Access Compliance Report

Public Rights-of-Way

Intersection ID: 13947	Main Street: CHERRY_ST	Cross Street: CHARLOTTETOWNE_AV	Location:	N
ADA ID: 11532E0E13B5	Ramp Type: PerpDiag	Initial Pass/Fail: Fail	Overall Compliance: No	Severity Score: 25
Codes/Mitigation Info/Possible Solution		Field Measurements/Component Compliance

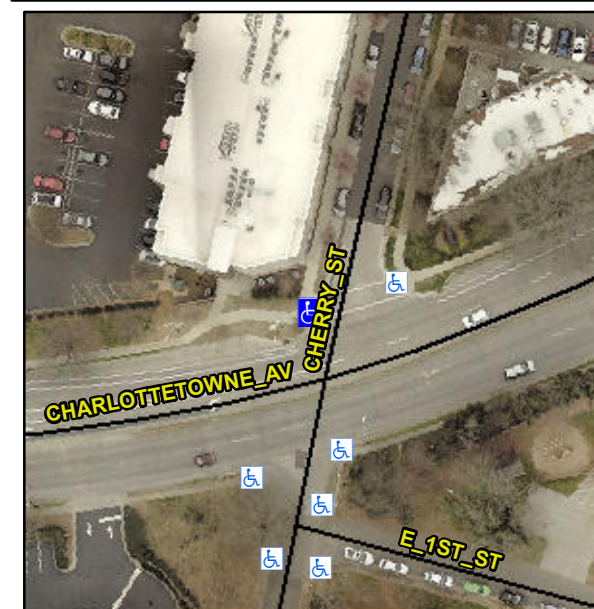
R304.2.2, R304.5.3

Compliance	Description	Data	Compliance	Description	Data
N/A	Ramp Length (in)	62.0	No	Ramp Slope (%)	9.2
Yes	Ramp Width (in)	48.0	No	Ramp XSlope (%)	5.6
N/A	Flare Type LT	N/A	N/A	Flare Type RT	N/A
N/A	Flare Slope LT (%)	N/A	N/A	Flare Slope RT (%)	N/A
N/A	Flare Traversable LT?	N/A	N/A	Flare Traversable RT?	N/A
N/A	Landing Length (in)	N/A	N/A	DWS Provided?	N/A
N/A	Landing Width (in)	N/A	N/A	DWS Contrast?	N/A
N/A	Landing Slope (%)	N/A	N/A	DWS Length (in)	N/A
N/A	Landing X Slope (%)	N/A	N/A	DWS Full Width?	N/A
N/A	Landing Curb? (Y/N)	N/A	N/A	DWS Offset (in)	N/A
N/A	Shared Landing?	N/A			
N/A	Gutter Ponding?	N/A	N/A	Gutter Slope (%)	N/A
N/A	Gutter Lip Ht (in)	N/A	N/A	Gutter X Slope (%)	N/A
N/A	Painted X Walk1?	No	N/A	Painted X Walk2?	Yes
	X Walk 1 Direction	To S		X Walk 2 Direction	To E
N/A	X Walk 1 Width (in)	N/A	N/A	X Walk 2 Width (in)	112.0
	X Walk 1 Slope (%)	1.4		X Walk 2 Slope (%)	3.2
	X Walk 1 X Slope (%)	5.4		X Walk 2 X Slope (%)	3.0

Remove & Replace Curb Ramp With Two New Directional Ramps or Equivalent.
